Council Transportation Committee Member Questions April 20, 2021 CTC Meeting

<u>Item 5.1 Grant Road and Sleeper Avenue Intersection Study</u>

Item 5.2 AccessMV: Comprehensive Modal Plan

Figure 4-3 Network Gaps

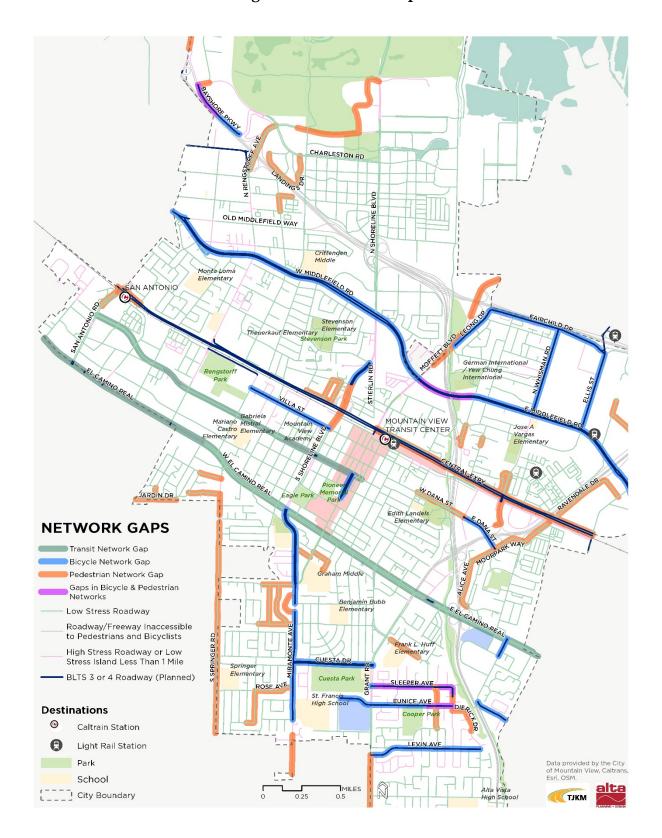
Page 95 of the Draft Access MV plan is missing the lower 2/3 of the page. Where can I find the complete map? Page 96 is blank. Is it supposed to be?

There was a glitch in importing the map into the document. Attached is the full map for Figure 4-3 Network Gaps on page 95. Page 96 is intentionally blank for pagination purposes.
